TI_2207: New control board (CPU board)

iCombi Pro

14/03/2022

New additional control board

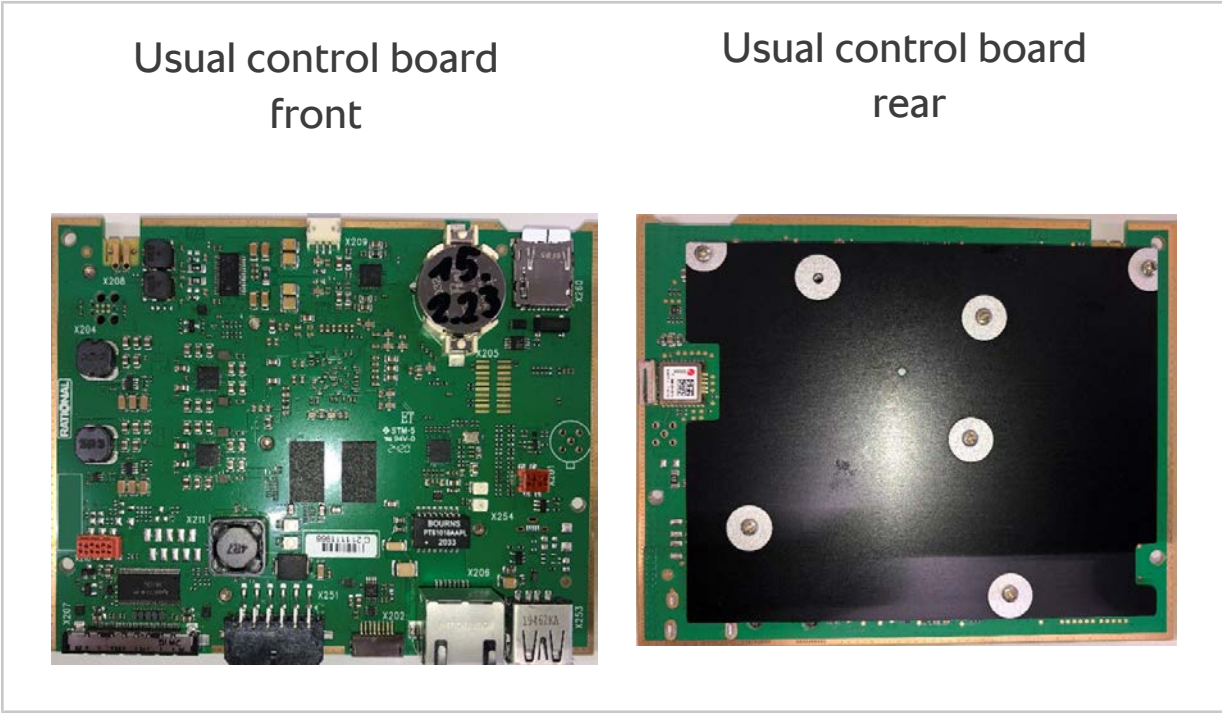
We would like to inform you that, since 08/03/2022, we have been using a new control board, Part no.: 42.00.251P as an alternative to the existing control board. This board is used exclusively for production and can only be operated with software version LM100 – 16.0.xx or higher.

There are no LEDs for error analysis on the new alternative control board. The existing Reset-to-Spare Part software cannot be used on the new control board either.

Both variants of the control board are now installed ex works. Only the previous usual control board will continue to be sent as a service part. This is compatible during service work. It is not possible to convert the new alternative control board in other units (in the event of service) and the board must therefore always be replaced in this case.
